Detailed Site Plan Departure from Design Standards Woodmore Commons

DSP-04067-09 DDS-669

SUBJECT: Detailed Site Plan DSP-04067-09

Woodmore Commons

Figure 3: Proposed Freestanding Sign

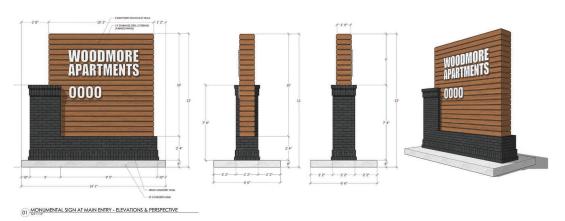
The DSP is not proposing any building-mounted signage, but does include one 13-foot-tall, double-faced monument sign along Ruby Lockhart Boulevard, near the entrance to the multifamily site. The sign is constructed of composite wood-slats and is mounted on a dark

gray masonry base matching the architecture of the multifamily buildings. The sign includes back-lit, white channel letters on the wood-slat wall that display the name and address of the development. The 14-foot-wide sign does not include landscaping at its base and is conditioned herein to be added to provide seasonal interest.

- f. Include landscaping at its base of the freestanding sign to provide for seasonal interest.
 - g. Provide a list of cost estimates, a floorplan, and a spreadsheet, in accordance with the values of the proposed private recreational facilities proposed with the DSP, in accordance with the Prince George's County *Parks and Recreation Facilities Guidelines*.
